Flight Procedures Cover Page	Task Action: FLIGHT CHECK	Task Type: IAP	Estimated Chart Date: 03/19/2026	APWS Task ID: 15ED409FD8194EF184BB78EB01B404F7	APWS Project ID: 00C896C3A8AF44F6BC889E6278105E1A
Procedure: RNAV (RNP) Z RWY 17L AMDT 1		Enroute: NO	Specialist: Hirst, Charles		Agreement Number:
Airport ID: KDEN			Airport City: DENVER		State: CO
Facility ID:	Facility Type:	Flight Inspection Remark Type: New FC Slot

Procedure Comments:
ADD INITIAL FIX GOLFN. REDESIGN MISSED APPROACH.

FIPC BASIC FORM							
PROCEDURE: RNAV (RNP) Z RWY 17L AMDT 1			AIRPORT NAME: DENVER INTL		AIRPORT ID: KDEN	SPECIAL CONTROL NO: SG-11-119-25	
FAC ID: KDEN17L.01Z		CITY: DENVER			ST: CO	ORIG CHART DATE: 03/19/2026	
DFL TYPE: PROC/P	THIRD PARTY: ☐ YES	EST. TIME ON SITE: 0.4	REIMB. NUMBER:		PTS TASK ID: 15ED409FD8194EF184BB78EB01B404F7		
PREFLIGHT NOTES							
REVIEWER:					DATE:		
COMMENTS:					CHECK ONE:		
					☐ FLT CK REQ ☐ NFCR ☐ REJECT		
							YES
					CPV COMPLETE?		X
PROCEDURE RESULTS							
INSPECTION DATE: 01/06/2026		CREW #: VN477	N #: N78	INSTRUMENT PROCEDURE STATUS: ☒ SAT ☐ SAT W/CHANGES ☐ UNSAT		ARINC CODING: ☒ SAT ☐ SAT/GOLD ☐ UNSAT	
FLIGHT INSPECTOR SIGNATURE: colton crowder @ 01/06/202

AUTOMATED AL-9077 RNAV (RNP) Z RWY 17L

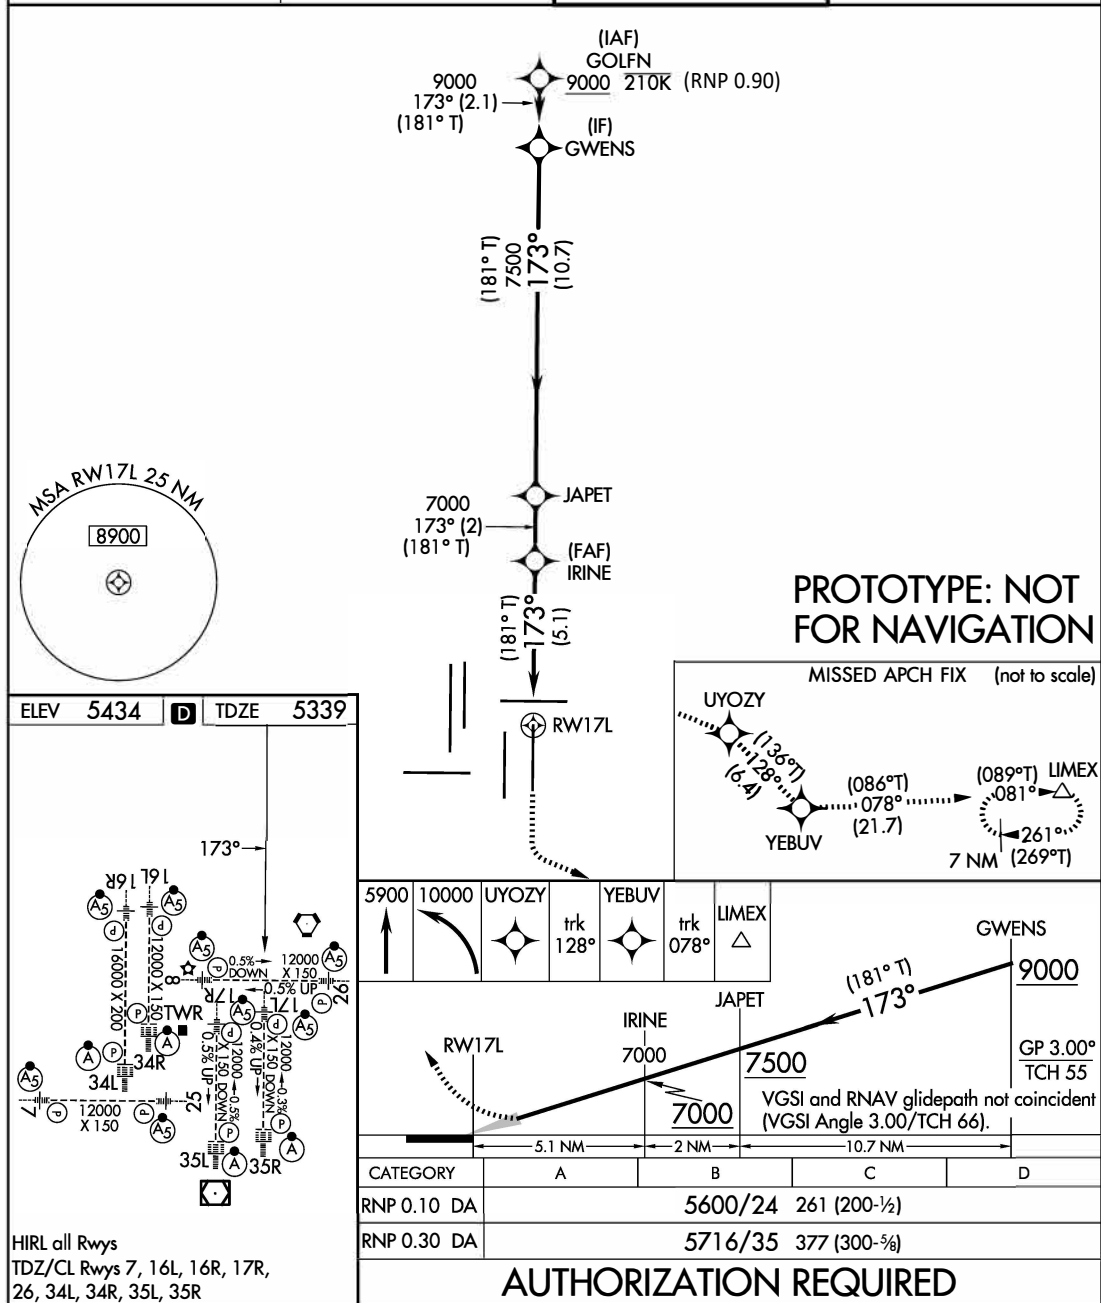
10/31/25: THIS IS AN UPDATED COPY OF THE FORM DEVELOPED ON 08/14/25:
1. NOTES REMOVED "CHART NOTE: USE OF FD OR AP PROVIDING RNAV TRACK GUIDANCE REQUIRED DURING
SIMULTANEOUS OPERATIONS."
8260-1:
1. UPDATED WAIVER TO REFLECT VECTOR ANGLE RESTRICTED AT GOLFN TO 45 DEGREES.

MISSED APPROACH: CLIMB TO 5900, THEN CLIMBING LEFT TURN TO 10000 DIRECT UYOZY AND TRACK 128.07 TO YEBUV AND TRACK 078.42 TO LIMEX AND HOLD.
